**United Kingdom
Civil Aviation Authority**

MPD No: 2010-004

MANDATORY PERMIT DIRECTIVE

Subject: Rocker Arm Inspection

Figure 1.

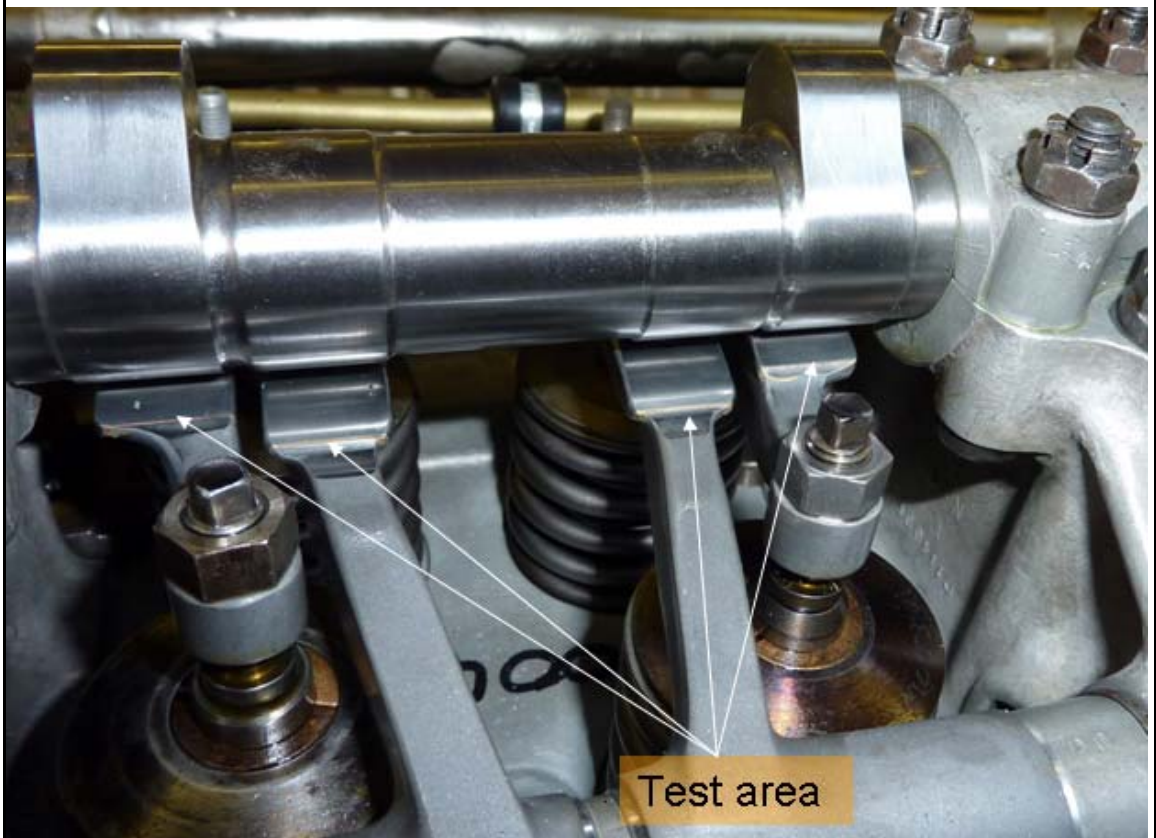
- a) Inspect each modified rocker arm fitted for detachment of the carbide pad. Remove from service any rocker arm, which exhibits a released pad along with the associated pad. Replace with a serviceable arm. If any pad cannot be located on the cylinder block carry out further in-depth inspection to locate the pad, if necessary by removing the engine. Rectify any damage caused by the released pad prior to engine release back to service.
- b) For the remaining modified rocker arms, inspect the region of the brazed joint between the carbide pad and the rocker arm as shown in figure 1 using a x10 glass or if preferred a stylus of maximum radius 0.005". Inspect for evidence of movement of the pad on the arm, which is revealed by a line indication or step on the arm.

In cases where movement is observed, carry out a comparison with a feeler gauge to measure the size of step. Any arm, which exhibits a step estimated at 0.005" or less may continue in service in accordance with paragraph (d). Any arm, which exhibits a step in excess of 0.005" but less than 0.015" is to be re-inspected at intervals in accordance with paragraph (c). Any arm, which exhibits a step of 0.015" or more, is to be removed from service.

- c) Re-inspect those rocker arms, which exhibit a step in excess of 0.005" but less than 0.015" at intervals not to exceed 15 flight hours or annually, whichever limit is reached first. At each re-inspection, reject any arm, which exhibits a step of 0.015" or more.
- d) Re-inspect rocker arms declared fully serviceable at 25-flight hour intervals or annually, whichever limit is reached first, in accordance with the previously defined maintenance regime for these arms.
